# **Alert J784S2 vE5 & J742S2 vE2 EVM System Updates**

**Notifying customers of EVM performance updates across both  
J784S4 & J742S2 EVMs and any J7 design using a universal PDN-3x scheme.**

**V1.0      9/12/2024**

# J784S4 (PROC141E5) & J742S2 (PROC184E2) Key Updates

PRGC141E4\_SCH (Nov 2022)

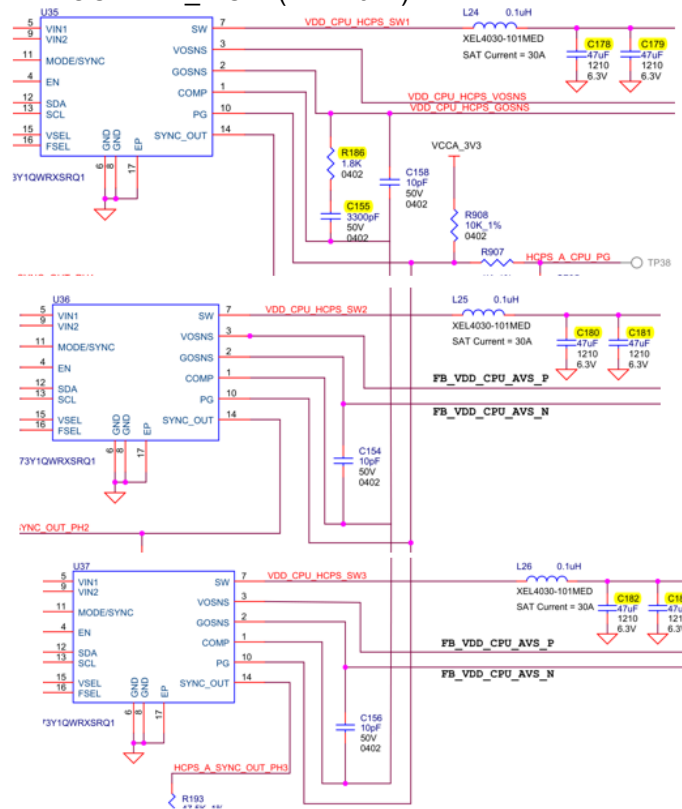
## • Update #1: HCPS-A, 3-Phase Buck for VDD\_CPU\_AVS

#### – PROC141E4\_SCH

- $R_z = 1.8k$  (R186)
- $C_c = 3,300pF$  (C155)
- $C_{c2} = 10pF$

#### – PROC141E5\_SCH (Impacts)

- $R_z = 2.4k$  (R186)
- $C_c = 1,500pF$  (C155)
- $C_{c2} = 10pF$

### • Local Cz per phase ( $C_z = C_{nom}$ derated by 50%) :

#### – PROC141E4\_SCH

- $C_{z\_out}$  per phase = 47uF  
(Note:  $C_z = C_{nom}$  derated by 50%)
- $C_{nom\_out}$  per phase = 94uF (C178 & 179; C180 & 181; C182 & 183)

#### – PROC141E5\_SCH (Impacts)

- $C_{z\_out}$  per phase = 11uF
- $C_{nom\_out}$  per phase = 22uF (C178; C180; C181)
  - PN: GCM32ER70J226KE19L, CERAMIC 22uF 6.3V 10% X7R AUTO 1210
  - DNI 3x capacitors (C179; C181; C182)

PROC141E4\_SCH (Nov 2022)

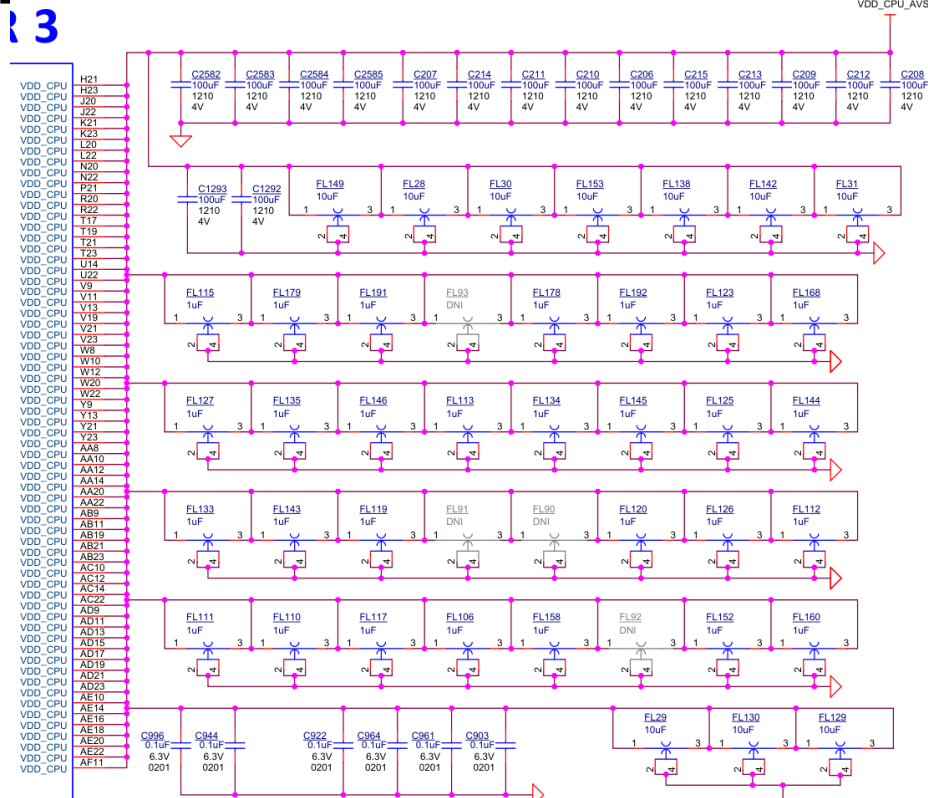
## • Update #1: HCPS-A, 3-Phase Buck for VDD\_CPU AVS

## • Point of Load Cz (Cz = Cnom typ derated by 50%):

### – PROC141E4\_SCH

- PoL Cz =  $1698 \times 50\% = 849\mu\text{F}$   
( $1698 \times 47\% = 900\mu\text{F}$ )
- $C_{\text{nom\_load}} = (16 \times 100\mu\text{F} + 7 \times 10\mu\text{F} + 28 \times 1\mu\text{F})$   
( $1600 + 70 + 28$ ) =  $1698\mu\text{F}$

### – PROC141E5\_SCH No Impacts for 47% derating

PROC141E4\_SCH (Nov 2022)

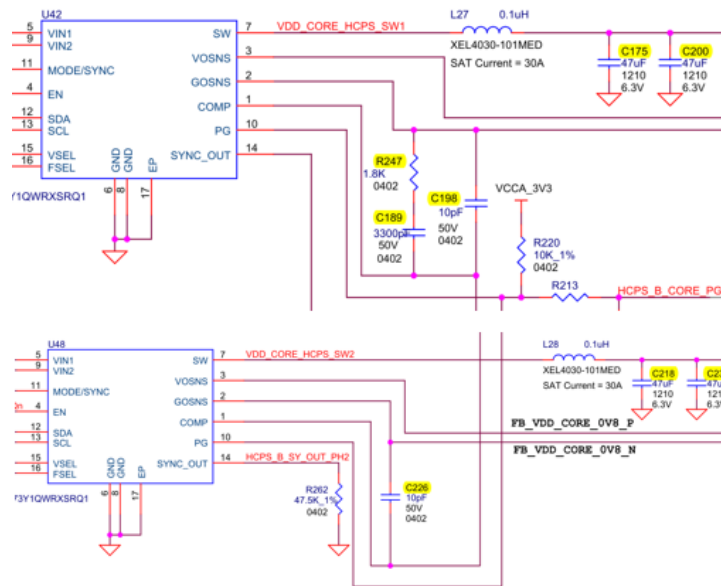
## • Update #2: HCPS-B, 2-Phase Buck for VDD\_CORE\_OV8

### • Buck loop compensation settings:

- PROC141E4\_SCH
  - $R_z = 1.8k$  (R247)
  - $C_c = 3,300pF$  (C189)
  - $C_{c2} = 10pF$  (C198 & C226)
- PROC141E5\_SCH (Impacts)
  - $R_z = 1.2k$  (R247)
  - $C_c = 4,700pF$  (C189)
  - $C_{c2} = 20pF$  (C198 & C226)

### • Local Cz per phase ( $C_z = C_{nom}$ derated by 50%) :

- PROC141E4\_SCH
  - $C_{z\_out}$  per phase = 47uF  
(Note:  $C_z = C_{nom}$  derated by 50%)
  - $C_{nom\_out}$  per phase = 94uF (C175 & C200; C218 & C236)
- PROC141E5\_SCH (Impacts)
  - $C_{z\_out}$  per phase = 23.5uF
  - $C_{nom\_out}$  per phase = 47uF (C175; C218)  
– DNI 2x capacitors (C200; C236)

- Update #2: HCPS-B, 2-Phase Buck for VDD\_CORE\_0V8 PROC141E4\_SCH (Nov 2022)

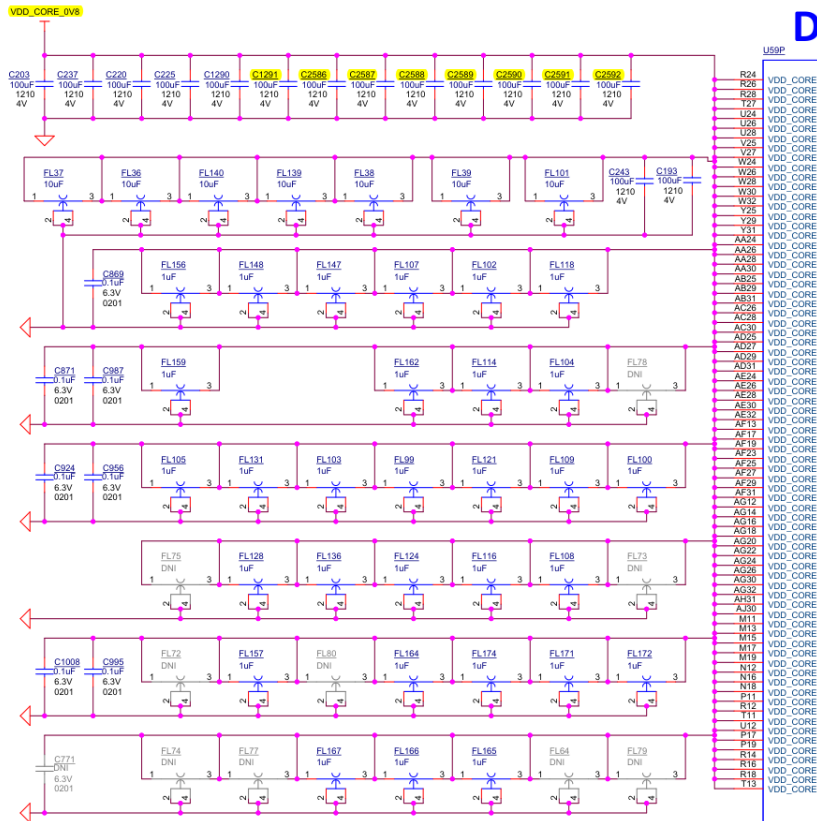
- Point of Load Cz (Cz = Cnom typ derated by 50%) :

- PROC141E4\_SCH

- PoL Cz =  $1600 \times 50\% = 800\mu\text{F}$
- PoL Cnom =  $(15 \times 100\mu\text{F} + 7 \times 10\mu\text{F} + 30 \times 1\mu\text{F})$   
 $(1500 + 70 + 30) = 1600\mu\text{F}$

- PROC141E5\_SCH Impacts, reduce PoL Cz

- PoL Cz =  $800 \times 50\% = 400\mu\text{F}$
- PoL Cnom =  $(7 \times 100\mu\text{F} + 7 \times 10\mu\text{F} + 30 \times 1\mu\text{F})$   
 $(700 + 70 + 30) = 800\mu\text{F}$

- DNI 8x capacitors (C1291, C2586 - C2592)

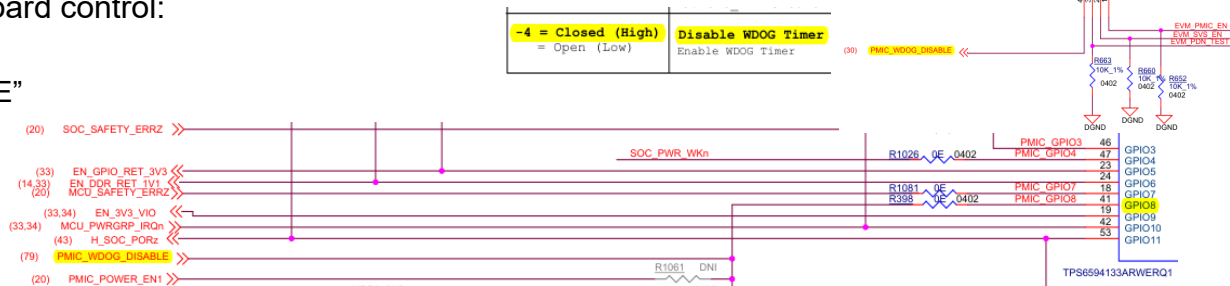
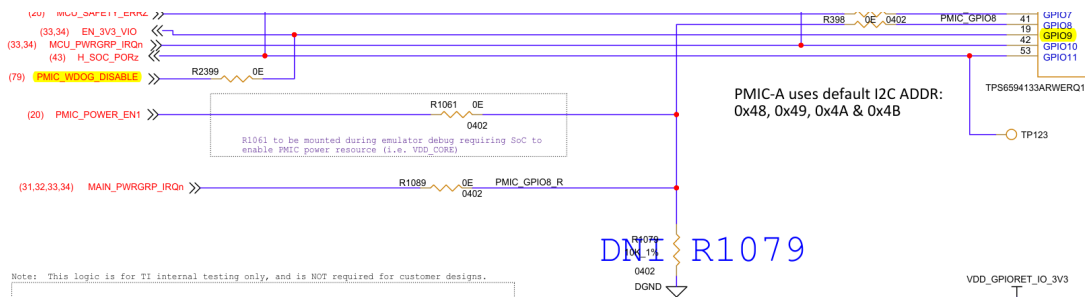
## • Update #4: PMIC GPIO8 connections

- “PMIC\_WDOG Disable” supported by GPIO8 per PMIC NVM v1 (Aug 2022)
- Wake-up EVMs used PCB designed per PROC141E3\_SCH (Sept 2022)

- PROC141E3/E4\_SCH
  - Originally “PMIC\_WDOG\_DIABLE” net connected to R398 (0-ohm) & interface to PMIC GPIO8

- PROC141E5\_SCH (Impacts)  
GPIO8 now supports a new “PDN Type”  
PMIC initialization control

Example: MAIN\_PWRGRP\_IRQn net connected to GPIO8 for EVM’s Isolated MCU & Main PDN-3A. Net is held low by low-voltage translator to keep HCPS-A & -B disabled until correct power up seq time step. Therefore, GPIO8 (PDN Type) latches a logic low to set Isolated MCU & Main PDN type.

## • Example PMIC GPIO8 connection for Grouped MCU & Main PDN-3G thru -3M

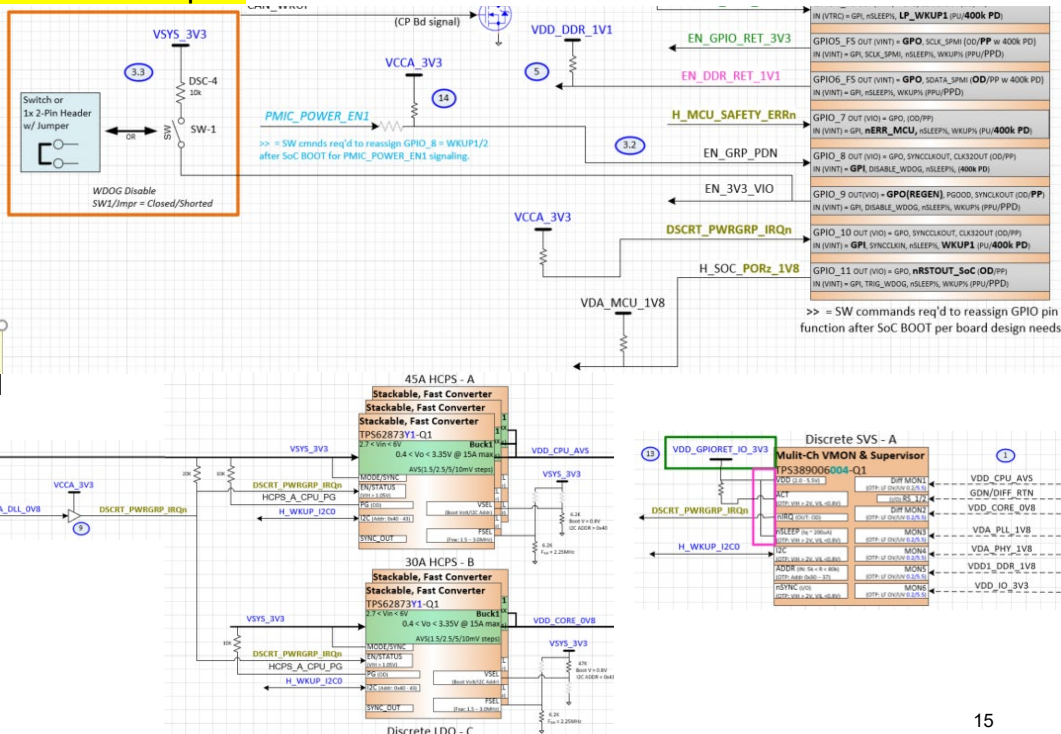
## • Detailed J784S4 PDN-3G diagram snap-shots are shown as examples:

- EN\_GRP\_PDN net connected to GPIO8 is pulled-up to VSYS\_3V3. Enabling the PMIC to latch a logic high during early portion of power up seq, resulting in Buck5 being disabled & removed from power up seq as desired for Grouped MCU & Main PDN-3G to -3M schemes.
- MCU\_PWRGRP\_IRQn net that is connected to GPIO10 for Isolated PDNs has been renamed to DSCRT\_PWRGRP\_IRQn. This distinguishes that only 1 common IRQn interface to PMIC is needed for both SVS-A & -B to provide VMON coverage across all discrete power resources.
- MAIN\_PWRGRP\_IRQn net that is connected to GPIO8 for Isolated PDNs is no longer needed since MCU & Main supplies are now grouped. Hence, GPIO8 can be used as a new "PDN Type" setting by installing an Rpu.

## • Update #5: PMIC GPIO9 connections

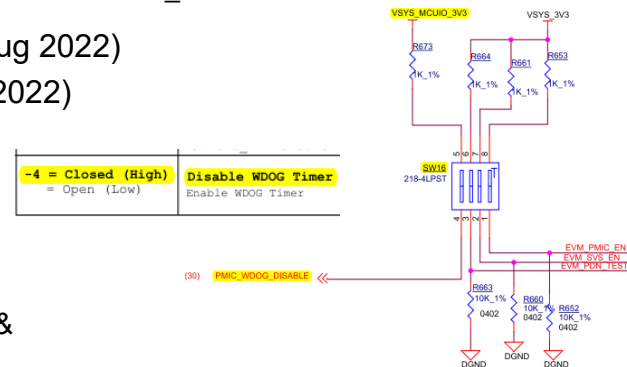
- “PMIC\_WDOG Disable” supported by GPIO8 per PMIC NVM v1 (Aug 2022)
- Wake-up EVMs used PCB designed per PROC141E3\_SCH (Sept 2022)

- PROC141E3/E4\_SCH
  - Originally “PMIC\_WDOG\_DISABLE” net connected to R398 (0-ohm) & interface to PMIC GPIO8

- “PMIC\_WDOG\_DISABLE” net moved to GPIO9

- **Update #6: Clearing asserted MCU\_PWRGRP\_IRQ**
- Safety Voltage Supervisors (TPS389006004-Q1) supply connection

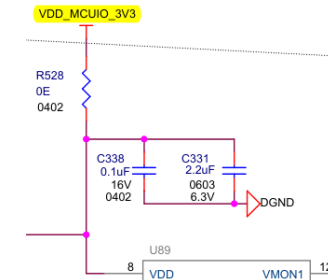
- Connected to VCCA\_3V3 = “always on” VSYS\_3V3

- Connect to VDD\_MCUIO\_3V3 supplied from PMIC LDO2 for PDN-3A to -3F.

- Connect to VDD\_GPIORET\_IO\_3V3 supplied from PMIC LDO2 for PDN-3G to -3M.  
(Source remains the same but net name changes due to Grouped MCU & Main PDN type.)

- Update #7: Improve discrete LDO slew rates
- Remove TPS74501P-Q1 optional feed-forward caps (Cff)
  - PROC141E4\_SCH
    - C192, C274 & C334 = 0.01uF
  - PROC141E5\_SCH (Impacts)
    - Remove C192, C274 & C334

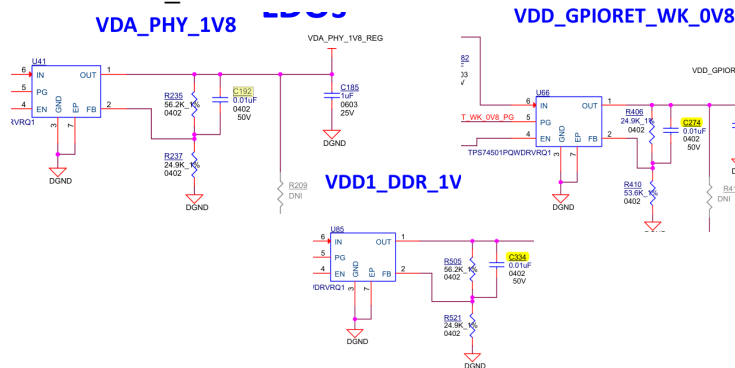
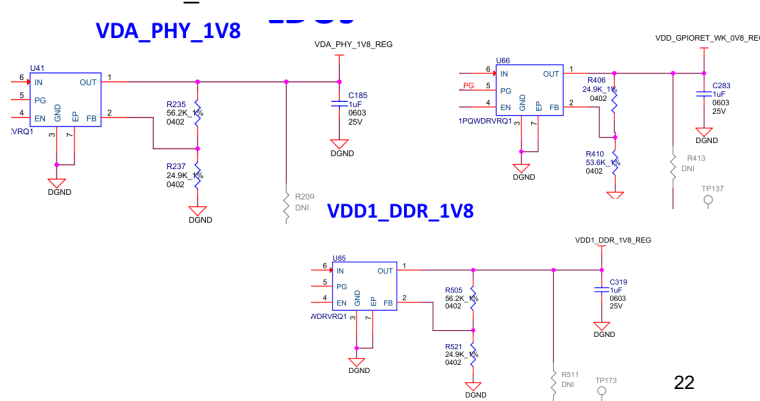
- **Criticality:** Medium
- **Description:** Discrete LDOs (TPS74501P-Q1) used to supply power rails VDD\_PHY\_1V8, VDD\_GPIORET\_WK\_0V8 & VDD1\_DDR\_1V8 have excessive ramp-up & down slew rates impacting desired power sequences. Optional feed-forward caps (Cff) were installed for improved noise & PSRR performance but previous J7 EVMs have not needed or used Cff caps.
- **Key Updates (Impacts):**
  1. Remove optional 0.01uF feed-forward caps (Cff) from all 3x TPS74501P-Q1 LDOs

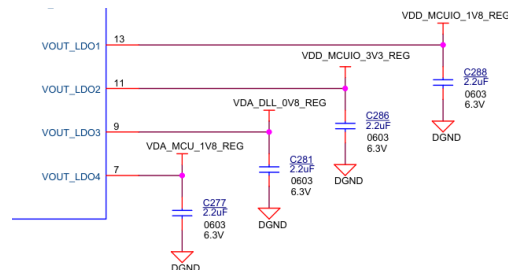
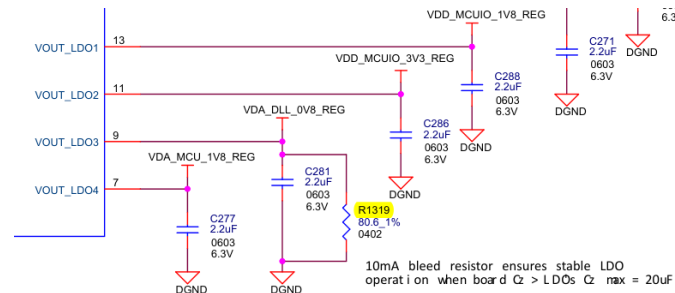
- **Criticality:** Low
- **Description:** PMIC's LDO3 output voltage stability for output capacitance exceeding data sheet max rating of 20uF at cold temperatures can be improved by installing a 10mA “bleed resistor” per PMIC team recommendation.
- **Key Updates (Impacts):**
  1. Add a 10mA “bleed resistor” on LDO3 Vout for a minimum load to avoid possible supply oscillations at low temperatures following LDO enabling with no load prior to booting SoC.

- **Update #8: PMIC LDO3 Coz > 20uF capacitance**
- LDO3 supplies power rail VDA\_DLL\_0V8
  - PROC141Ex\_SCH
    - VDA\_DLL\_0V8 rail supports 4x DDR & 1x MMC0 PLL input supplies that require low freq, low noise performance with 1.0 & 10uF decoupling caps recommended.
    - Cnom total = Cnom\_local + Cnom\_PoL = 2.2uF + 5x11uF = 57.2uF
    - Cz total = 57.2 x 50% = 28.6uF > 20uF max Cz
  - PROC141E5\_SCH (Impacts)
    - Add 80.6 ohm R1319 to LDO3 Vout
      - 10mA bleed resistor to VDA\_DLL\_0V8
      - Recommended by PMIC team to avoid instability & oscillations especially at start-up when LDO loads are not active yet.

- **Update #9: Optional customer eFuse programming**

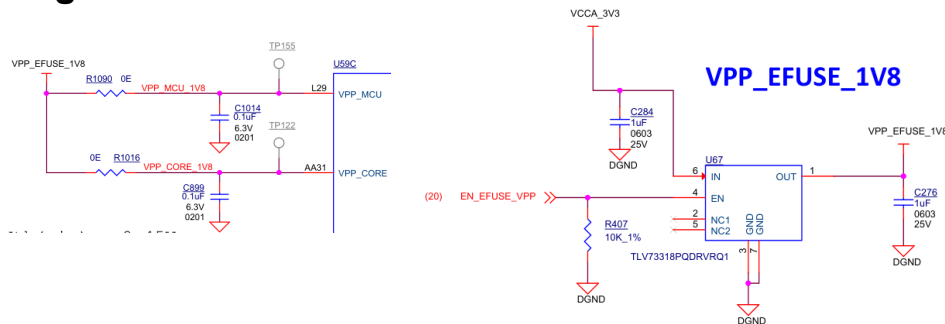
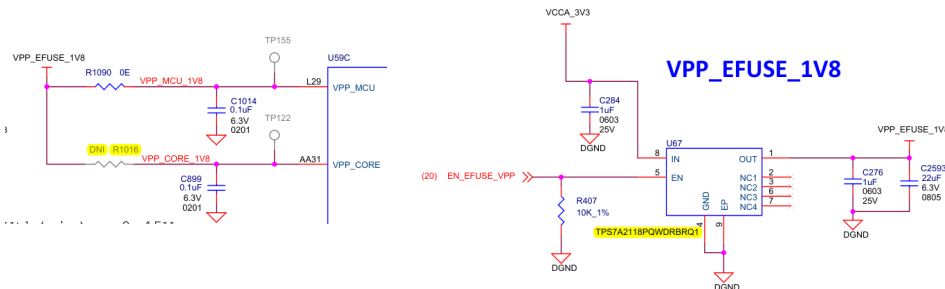
- Only MCU eFuse support customer programming & improve LDO drive strength for burning customer eFuses

- Originally install 2x 0-ohms at R1090 & R1016
- Originally U67 used a 300mA LDO (TLV73318P-Q1)

- DNI 0-ohm at R1016
- Replace U67 with 500mA LDO (TPS7A2118P-Q1)
